<b>DOCKETED</b>	
<b>Docket Number:</b>	23-SB-100
<b>Project Title:</b>	SB 100 Joint Agency Report
<b>TN #:</b>	258623
<b>Document Title:</b>	Southern California Gas Company Comments on the CEC SB 100 Demand Scenarios
<b>Description:</b>	N/A
<b>Filer:</b>	System
<b>Organization:</b>	Southern California Gas Company
<b>Submitter Role:</b>	Public
<b>Submission Date:</b>	8/21/2024 4:50:14 PM
<b>Docketed Date:</b>	8/21/2024

**SoCalGas Comments on the CEC SB 100 Demand Scenarios**

**Subject: Comments on the SB 100 Demand Scenarios Workshop**

**Figure 1: Final Energy Demand in Industrial Manufacturing (left) and in Oil and Gas Extraction and Petroleum Refining (right) in the Scoping Plan Scenario<sup>8</sup>**

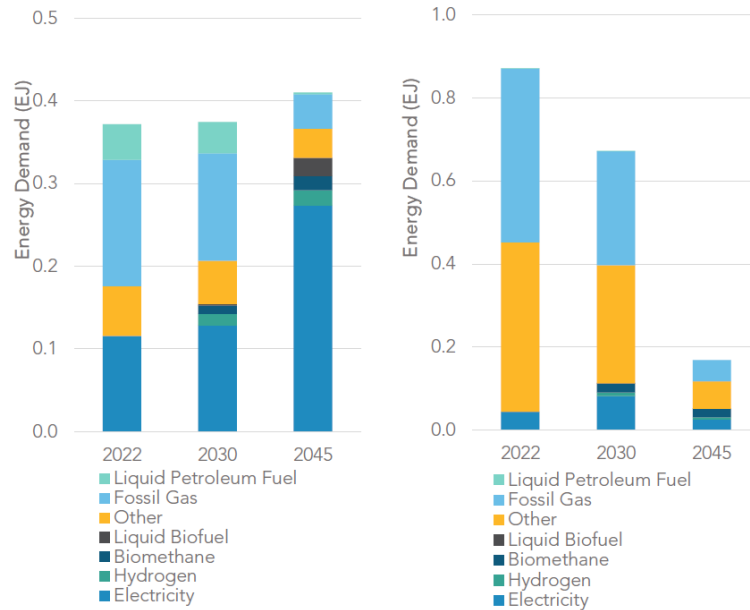
Understanding the details of how electricity and hydrogen in industry are being considered in the SB 100 Demand Scenarios are important for planning the energy system of the future. Inclusion of hydrogen as a pathway for industrial decarbonization would be a reasonable SB 100 load modifier for the Policy Scenario (High Hydrogen Use). The figure below (on the left) shows fuel substitution of electricity and hydrogen from the 2022 Scoping Plan. We would like the Commission to assess how this energy consumption trajectory is being incorporated into the SB 100 Demand Scenarios.
